R. E. GINNA NUCLEAR POWER PLANT

AMENDMENT TO PROVISIONAL OPERATING LICENSE

Amendment No. 7  
License No. DPR-18

ATTACHMENT TO LICENSE AMENDMENT NO. 7  
CHANGE NO. 16 TO THE TECHNICAL SPECIFICATIONS  
FACILITY OPERATING LICENSE NO. DPR-18  
DOCKET NO. 50-244

Figure 3.10-3 Normalized Axial Dependence Factor  
for  $F_Q$  versus Elevation

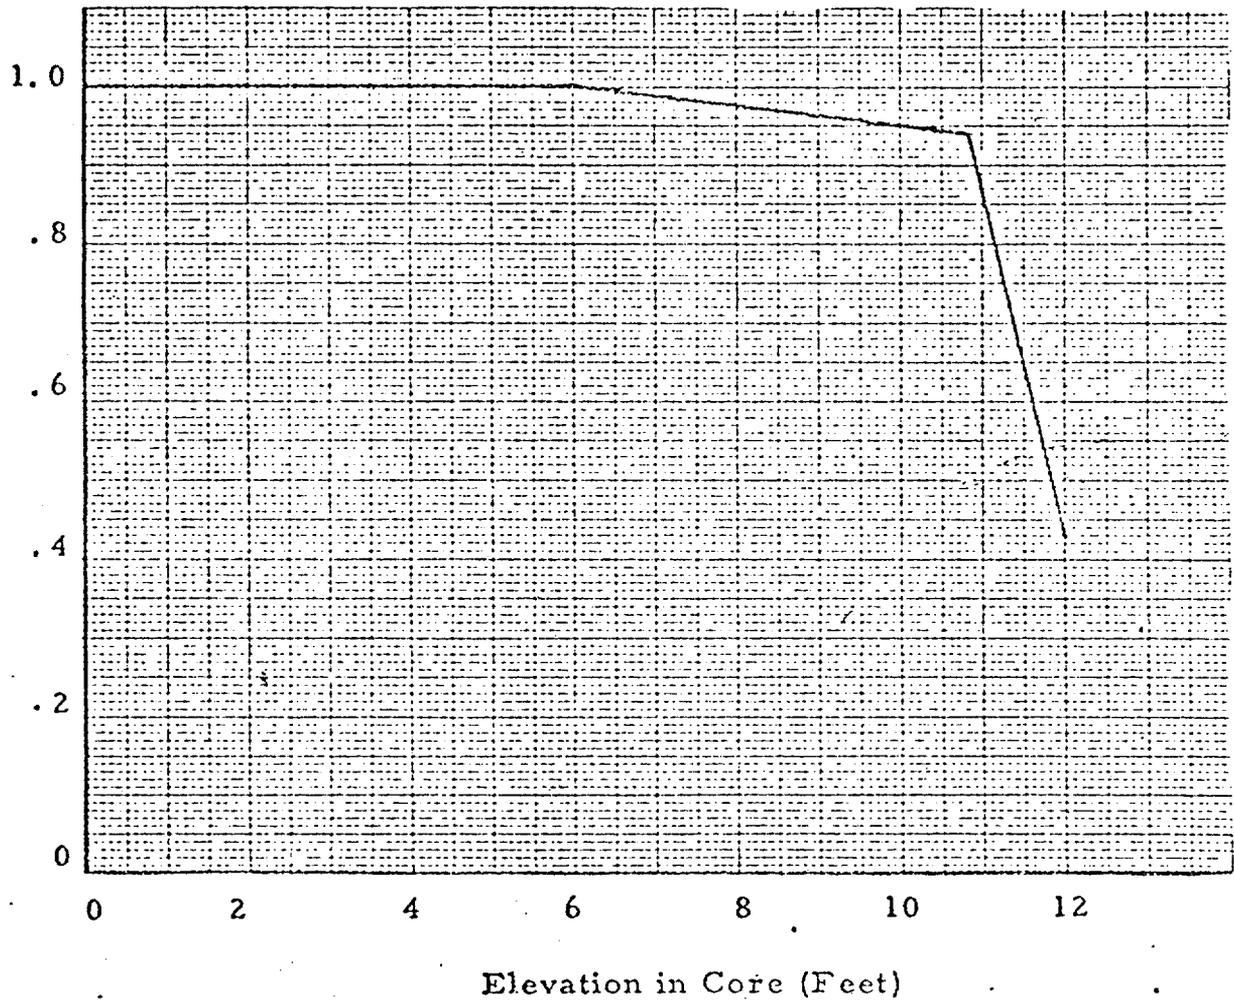
where P is the fraction of rated power at which the core is operating, K(Z) is the function given by Figure 3.10-3, and Z is the height in the core. The measured  $F_Q^N$  shall be increased by three percent to yield  $F_Q$ . If the measured  $F_Q$  or  $F_{\Delta H}^N$  exceeds the limiting value, with due allowance for measurement error, the maximum allowable reactor power level and the Nuclear Overpower Trip set point shall be reduced one percent for each percent which  $F_{\Delta H}^N$  or  $F_Q$  exceeds the limiting value, whichever is more restrictive. If the hot channel factors cannot be reduced below the limiting values within one day, the Overpower  $\Delta T$  trip setpoint and the Overtemperature  $\Delta T$  trip setpoint shall be similarly reduced.

An upper bound envelope of 2.32 times the normalized peaking factor axial dependence of Figure 3.10-3 has been determined from extensive analyses considering operating maneuvers consistent with the technical specifications on power distribution control as given in Section 3.10. The results of the loss of coolant accident analyses based on this upper bound envelope demonstrate compliance with the Final Acceptance Criteria limit for Emergency Core Cooling Systems.

The technical specifications on power distribution assure that the  $F_Q$  upper bound envelope of 2.32 times Figure 3.10-3 is not exceeded and xenon distributions are not developed which, at a later time, could cause greater local power peaking even though the flux difference is then within the limits.

$$F_Q(Z) = (2.32/P) * K(Z) \quad \text{for } P \geq .5$$

$$F_Q(Z) = 4.64 * K(Z) \quad \text{for } P \leq .5$$
